919 Spaight Street
Certificate of Appropriateness
August 19, 2024

Proposed Work

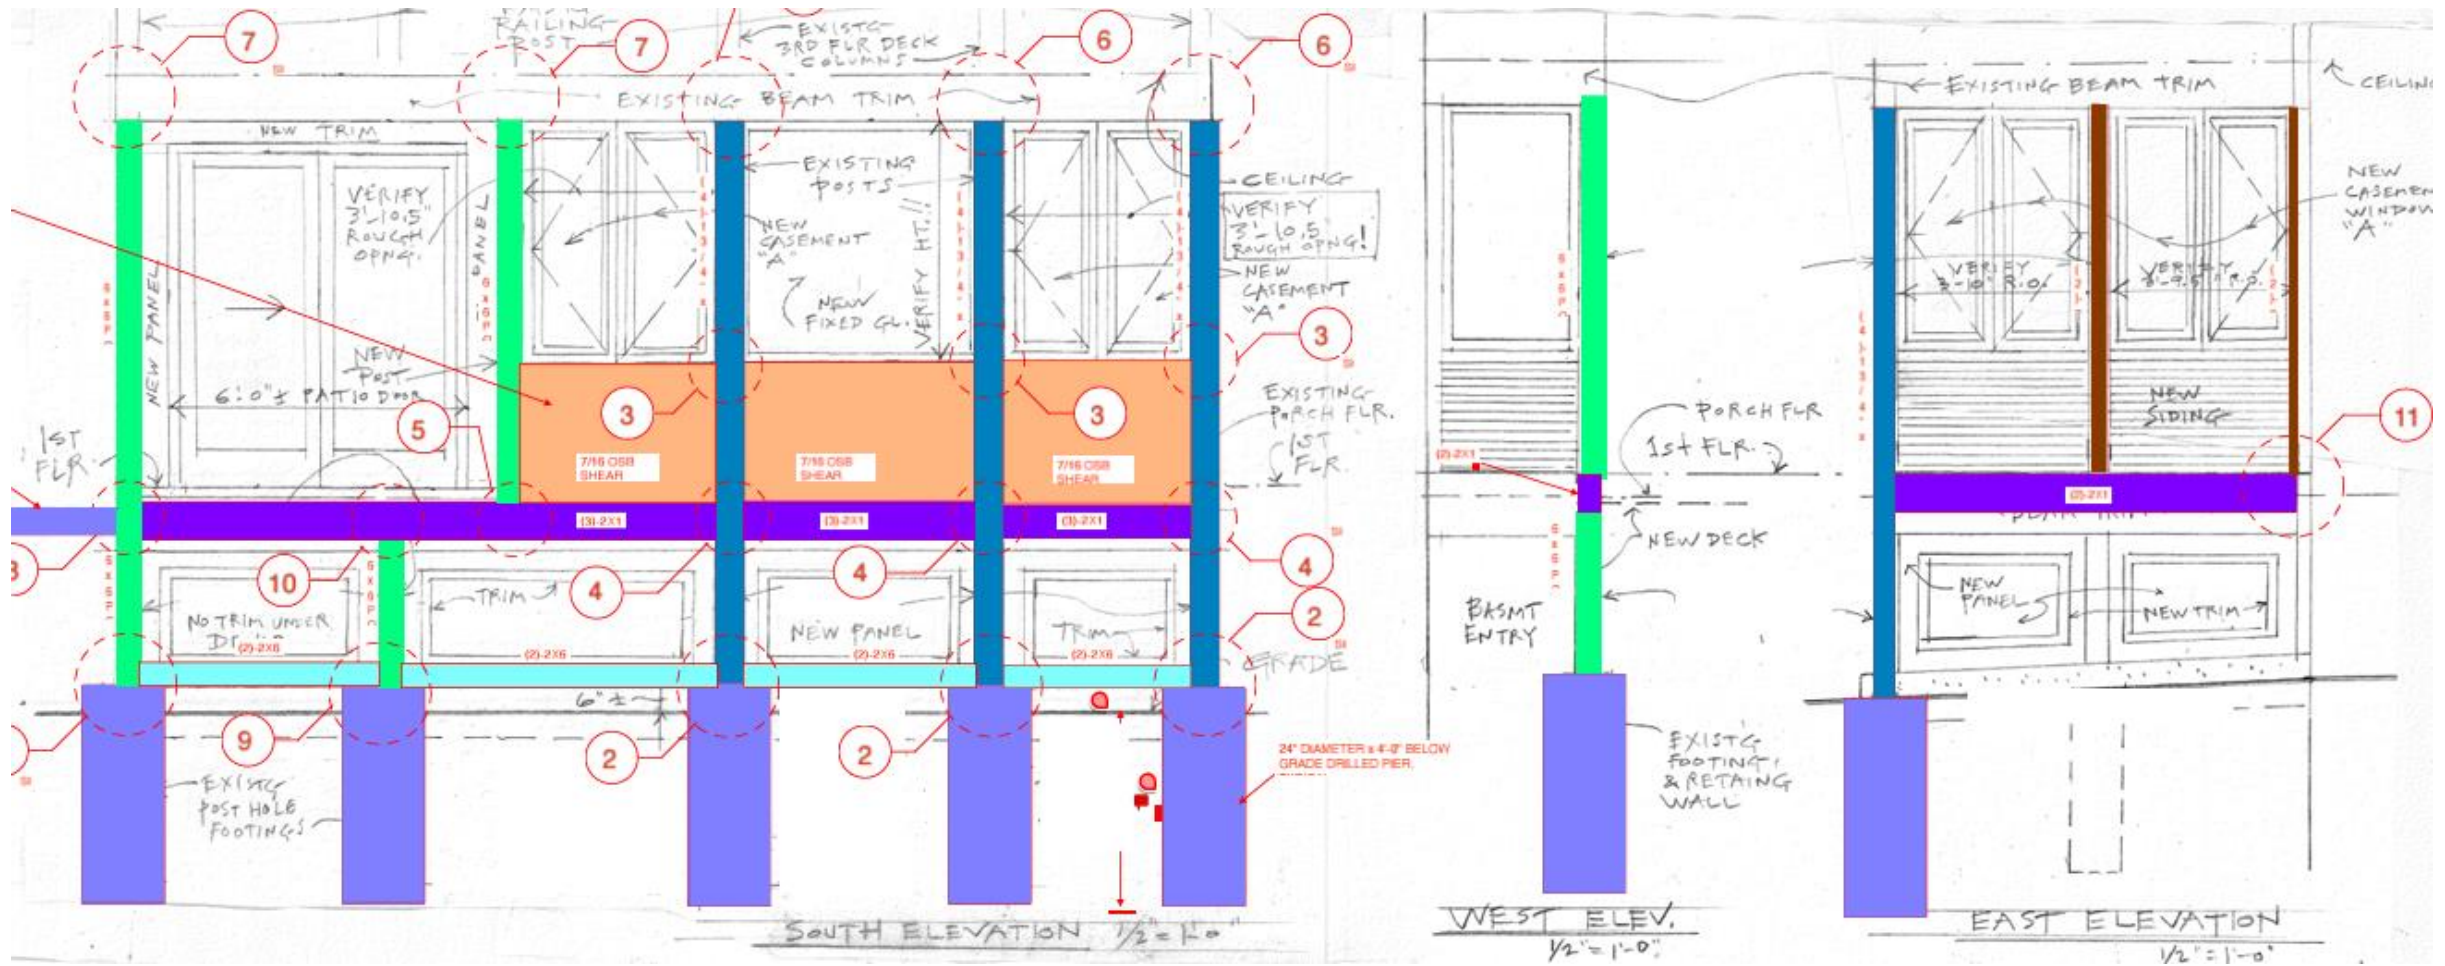
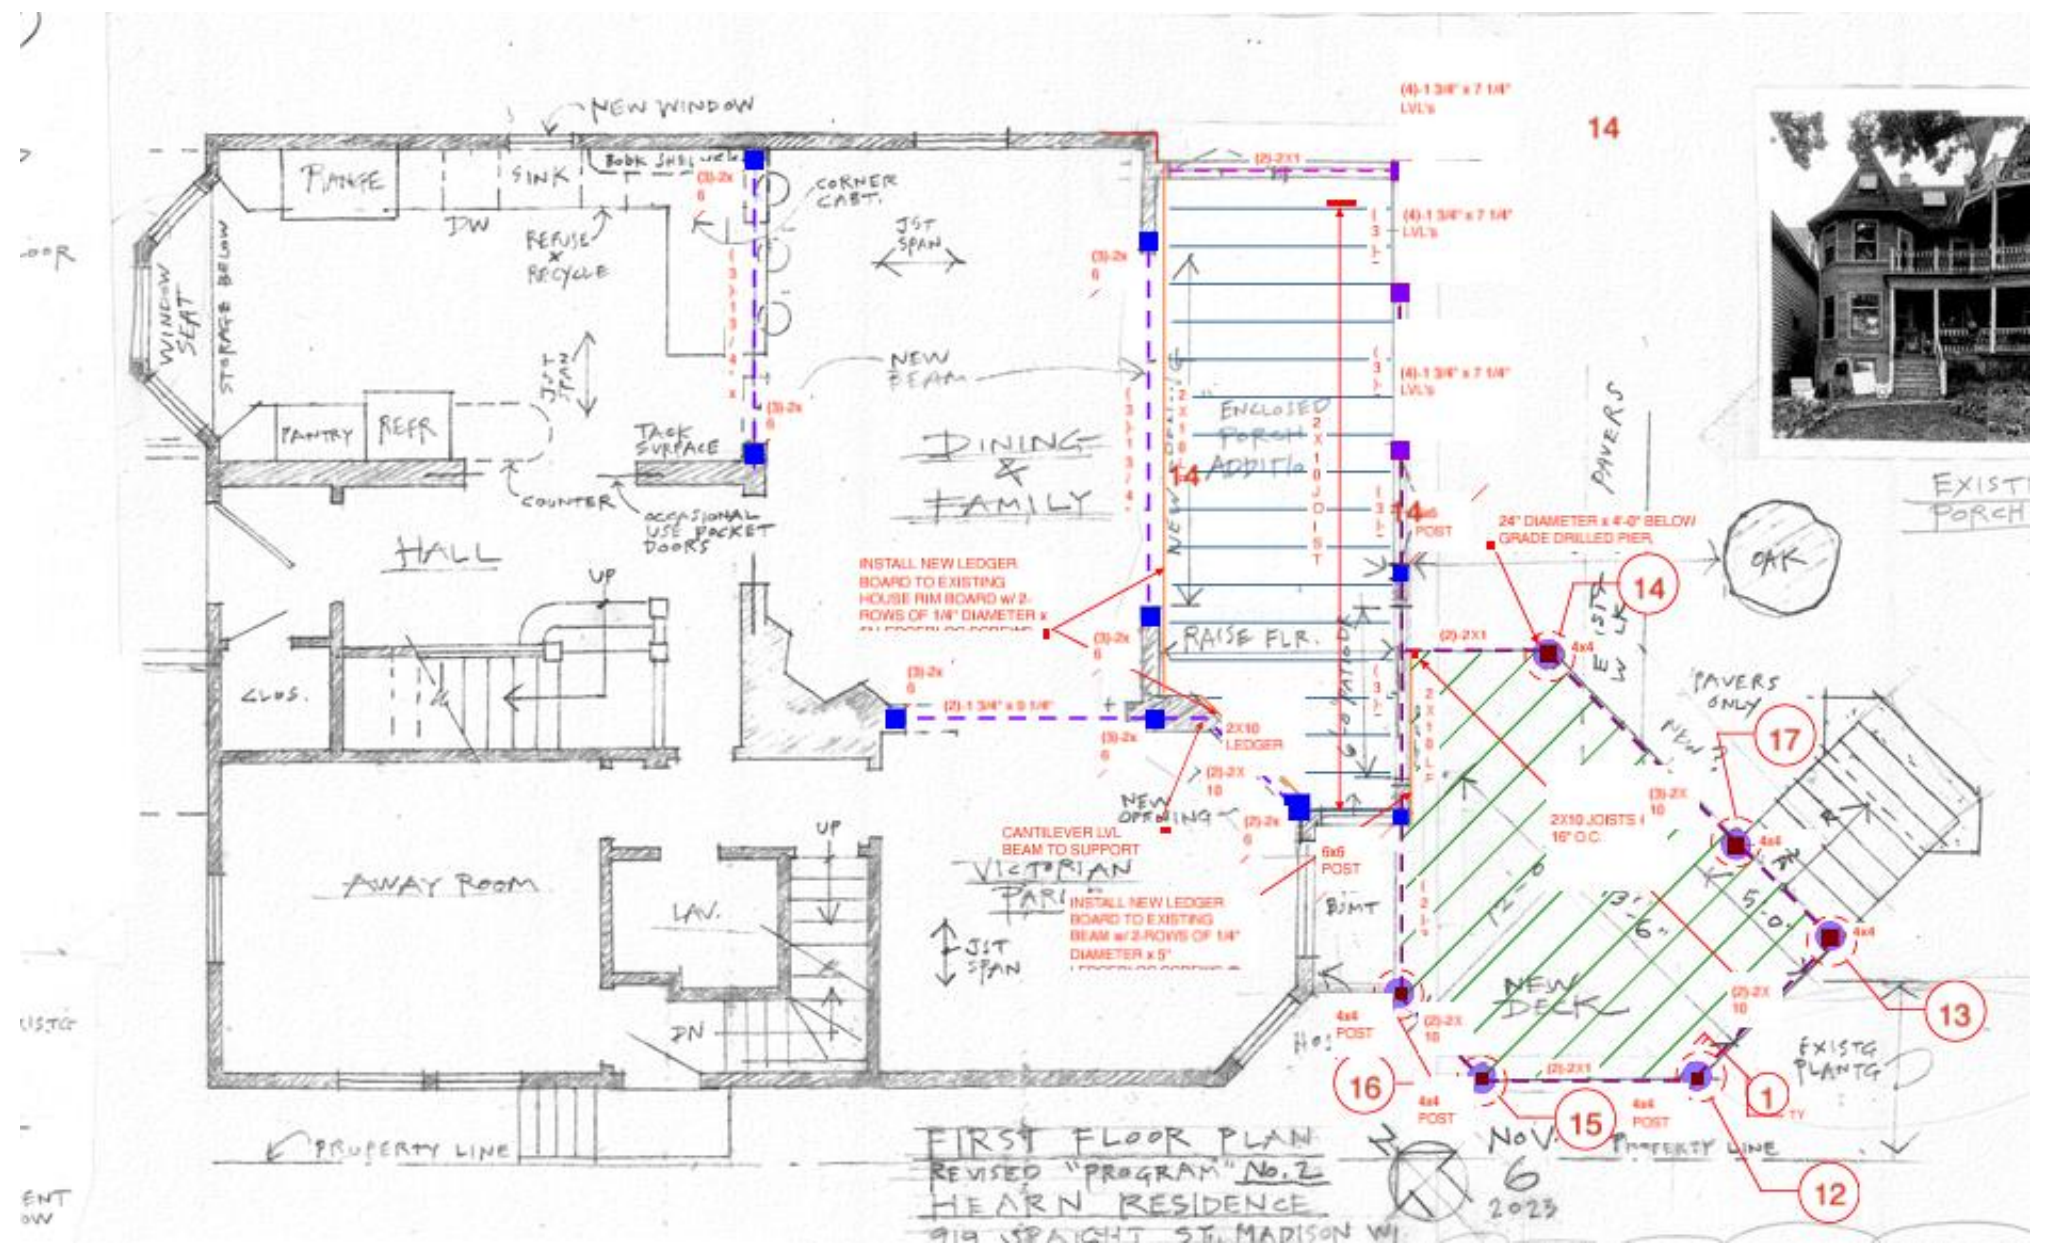
- Enclose first-floor level of 3-story rear porch
- Construct rear yard deck

Not meeting: MGO 41.26 (5) Windows and Doors

Staff believes that the **standards for granting a Certificate of Appropriateness are not met** and recommends the Landmarks Commission either move to place the project on file without prejudice with the finding that the proposal does not meet the standards of approval for window and door design, or with the permission of the applicant, refer to a future meeting with specific direction to the applicant on how to update their design to meet the standards.
